# Transit Mall Feedback

A Response to the “Portland Transit Mall Revitalization Conceptual Design Report”

October 21, 2003

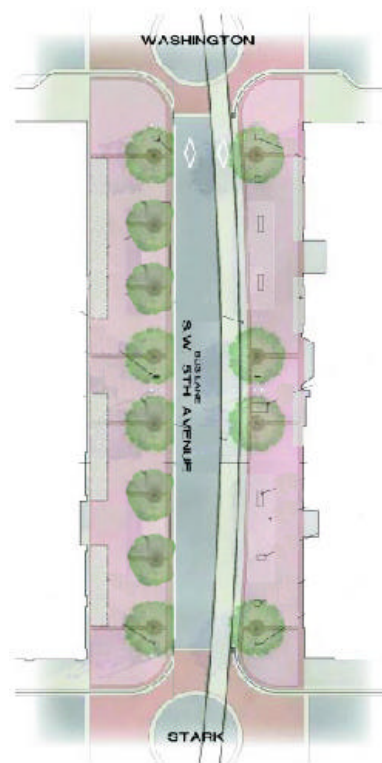
The proposed alignment from Union Station southward should provide excellent service along the spine of downtown.

It is recommended that funding options be pursued to implement the full proposal all the way south to the PSU campus for maximum ridership and flexibility in train turning and scheduling.

The proposed spacing of light rail stations every 4 or 5 blocks should provide better average speeds than the current 2 block spacing of east-west light rail stations downtown. Signal automation, timing, and operating speed limits should be adjusted to maximize speed of operation.

Existing east-west light rail suffers from a perception of slow performance downtown. The transit mall alignment should also be viewed as an opportunity to slightly reduce the number of stops on the east-west line to improve operational speeds downtown.

*Asphalt diminishes the look.*

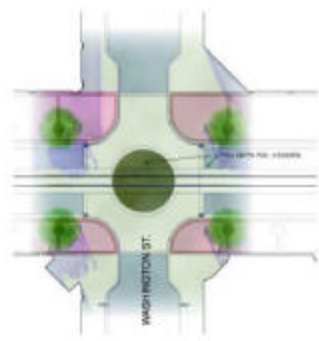
The current intersection treatments represent a high quality of design and materials. It is understood, however, that over time these materials have proven difficult and expensive to maintain.

The Conceptual Design Report shows several alternatives. Because of the public benefit of preserving an attractive Transit Mall appearance reflective of the other high quality materials in the mall, the pure asphalt with thermoplastic stripping method would be undesirable.

Using less expensive, easily maintained materials is a worthy goal, but must be done in a way that preserves the overall look of the current treatments. The suggested alternative of replacing existing materials with full-depth concrete is intriguing, and would be acceptable if the concrete can be colored (and perhaps textured) to simulate the current red paver layout.

*Full-depth concrete is easy to maintain.*

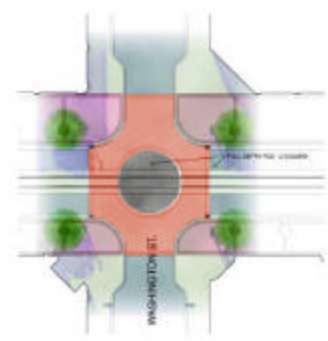
*Recommended:  
Colored/textured full-depth concrete would mimic the current treatment.*
